Product Change Notification

Date Issued :	May 27, 2022	PCN Number :	512108
Reason for Change :	Obsolete		
Description of Change :	This notification is to inform you about the Obsolescence of parts(s) referenced in this notice. Please connect with your Molex Sales Engineer for additional queries related to possible replacement part(s).		
Reason for Short Notice :	Force Majeure		
Planned Implementation Date :	September 20, 2022		
Recommended replacement parts :	Please see the attached replacement parts list .xls file.		
Last Time Buy Date for Obsolete Parts :	June 20, 2022		
Last Time Ship Date for Obsolete Parts :	September 20, 2022

SFP+/ZSFP+ Ganged Cage

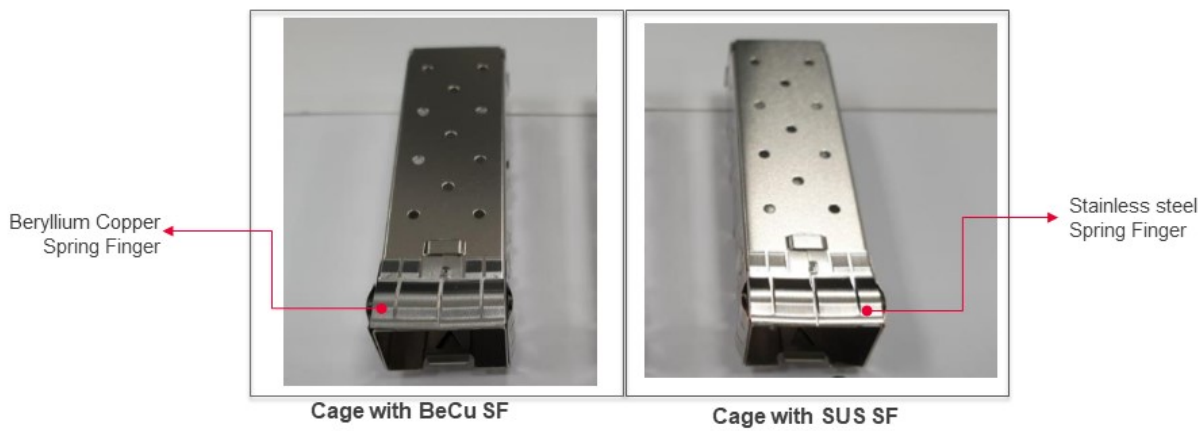
- Please be advised that the following Part numbers from the SFP+/ZSFP+ Ganged cages product families are being made Obsolete with replacement. The spring fingers of the offered replacement parts will be made of Stainless Steel.

- Reason for Change
 - Critical shortage of Beryllium Copper which is the raw material used in spring fingers of the affected parts.

- Product Impact
 - No impact to fit ,form or function based on test summary 747548001 (available upon request).
